DEVELOPMENT APPLICATION ASSESSMENT REPORT

Application Number:	DA2024/1530		
Responsible Officer:	Olivia Ramage		
Land to be developed (Address):	Lot G DP 400696, 2131 Pittwater Road CHURCH POINT NSW 2105		
Proposed Development:	Alterations and additions to a dwelling house including a swimming pool		
Zoning:	C4 Environmental Living		
Development Permissible:	Yes		
Existing Use Rights:	No		
Consent Authority:	Northern Beaches Council		
Land and Environment Court Action:	No		
Applicant:	Louise Anne Dowe		
Application Lodged:	28/11/2024		
Integrated Development:	No ·		
Designated Development:	No		
State Reporting Category:	Residential - Alterations and additions		
Notified:	09/12/2024 to 14/01/2025		
Advertised:	Not Advertised		
Submissions Received:	0		
Clause 4.6 Variation:	4.3 Height of buildings: 4.7%		
Recommendation:	Approval		
Estimated Cost of Works:	\$ 2,972,411.00

Figure 1 - Section plan showing extent of height variation

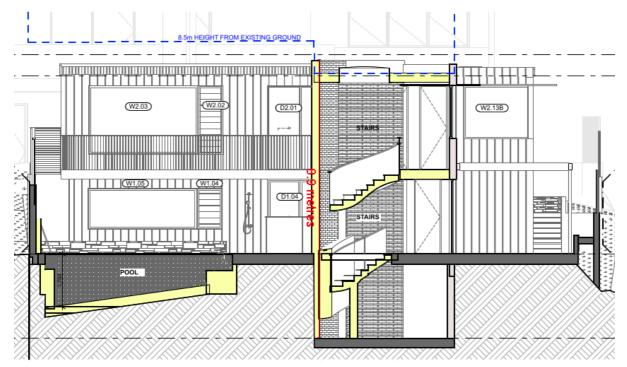
Percentage of variation: 4.7%

- The non-compliance arises due to historical excavation undertaken for the lower floor level of the existing dwelling. Based on the Merman Investments Pty Ltd v Woollahra Municipal Council [2021] NSWLEC 1582 judgement, the prior excavation of the site within the footprint of the existing building distorts the height of buildings development standard plane overlaid above the site when compared to the topography of the hill.
- The aspect of the development causing the breach relates to a portion of the stairwell and lift area that is sited above the excavated lower level. This element does not directly result in any increase in bulk or scale.
- The proposed development provides improved amenity through more functional floor space and good design promoting the orderly and economic use of the land.

Council is satisfied that the Applicant has demonstrated that there are sufficient environmental planning grounds to justify the contravention of Clause 4.3 Height of Buildings for the following reasons:
